Product Bulletin

Product: LA GARD 5750/5750-K Input Unit

Subject: Removable Battery Door

Bulletin #33

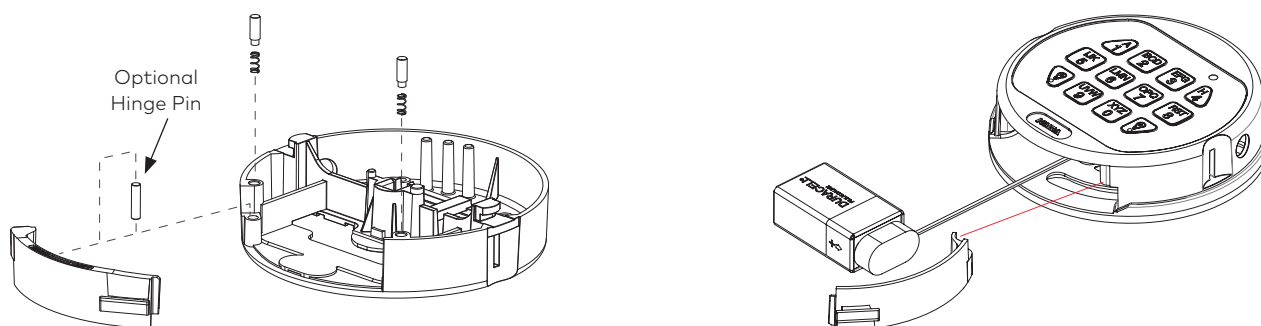
The battery door design for the 5750 and 5750-K Input Units has been improved to allow the installer to choose whether to affix the door using a hinge pin or to leave the door detachable. This allows the installer to determine the best method for battery exchange. The latter may be necessary in the case where there is limited clearance between the input unit and the safe handle or simply may be a user preference.

Full extension of the door will require clearance of 5 cm or more.

The battery door design now includes an optional hinge pin that is inserted when the input unit is first installed.

Without the hinge pin the battery door is detached during opening. To reinstall it, orient the hinge hook to the right, place the hinge hook onto the battery door post of the keypad, and rotate clockwise to the left until the handle is secured inside the left edge of the keypad housing.

The new battery door design will ship with production units starting on 10 July 2018 included in the hardware pack with each keypad. The new design is also backward compatible with any 5750 or 5750-K units since their launch. Replacement kits for retrofit (P/N 704150) consist of a battery door, hinge pin and dial plate.
